**ROCK RIVER WATER RECLAMATION DISTRICT
RFP #18-217 CORE SWITCH REPLACEMENT
ADDENDUM NO. 1**

September 25, 2018

RRWRD
Switch Block Diagram
For Reference Only
09/24/2018

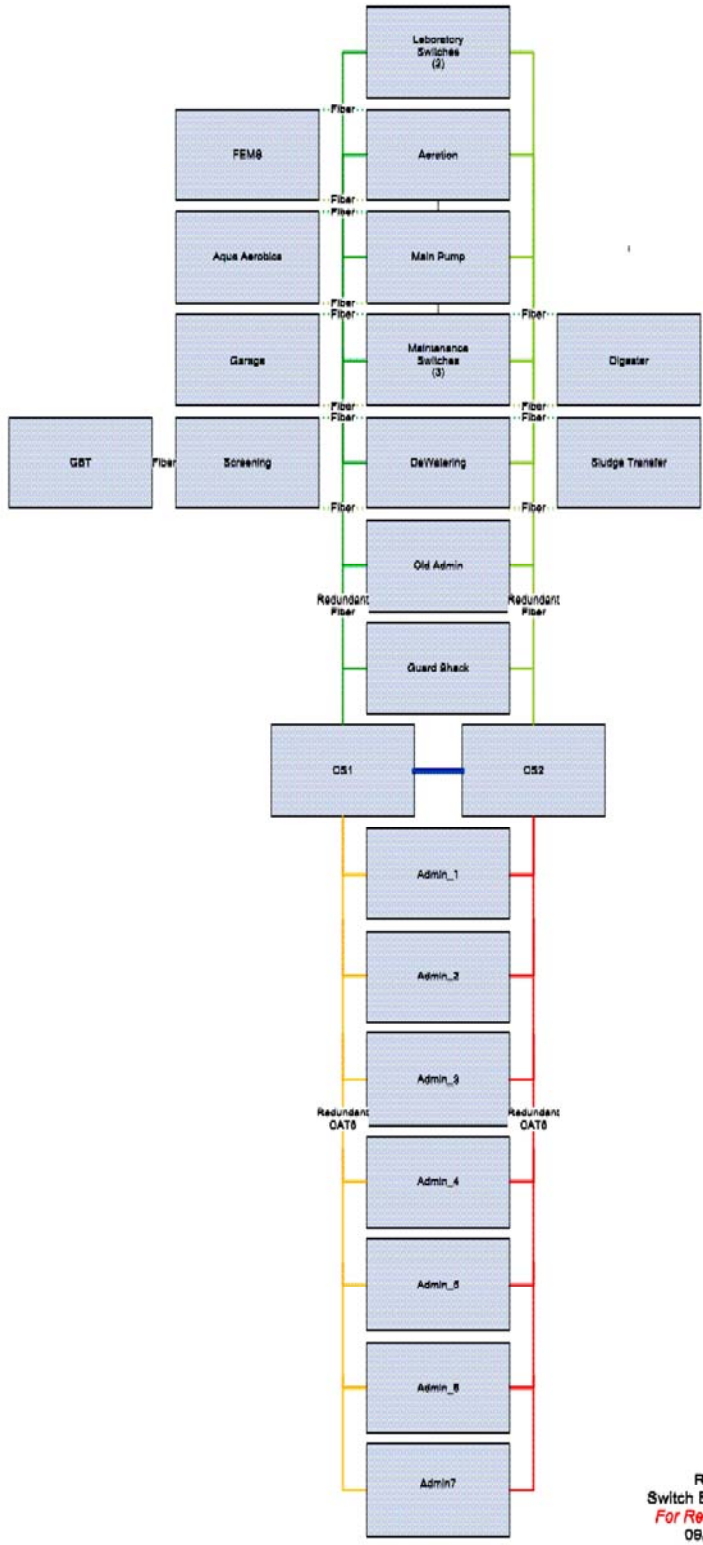
1. Is a network diagram available? Yes, see attached.
2. Are optional switches optional in purchase, or in timing? If the District has the money, this will probably be done.
3. Has maintenance been done on core switches? Items under HP warranties have been addressed, and cleaning has been done. Firmware updates have been done when required – releases are fairly current.
4. Will trunking (port aggregation) into servers occur? No.
5. Is support required? Nothing above the standard, proposers may offer additional options in responses.
6. P.O.E.? No – current core switches do not support P.O.E. Edge switch replacement will be P.O.E
7. Any need for switches to be voice? The District's Avaya phone system uses VoIP. Voice data is segmented on its own VLAN.

- Part numbers are for reference only.
- RRWRD will do configuration.
